Technical Service Bulletin No. 27

Created by: Lab.gruppen AB Service Department

Reference no: C12

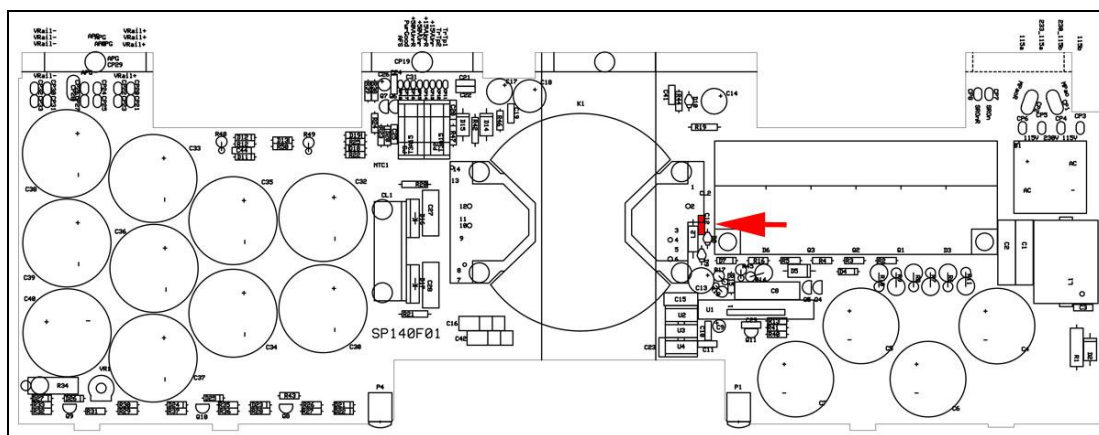
Screaming sound from power supply if amplifier powers up.

Amplifier does not power up.

Replace capacitor C12 with either of below listed components.

Lab Part No.	Description	Amount	Info	Pos
6n8250VMMK5	Wima: FKS2 6800PF 10% 400VDC	1		C12
6n8250VMMK5	Epcos: B32529-C3682-K289	1		C12
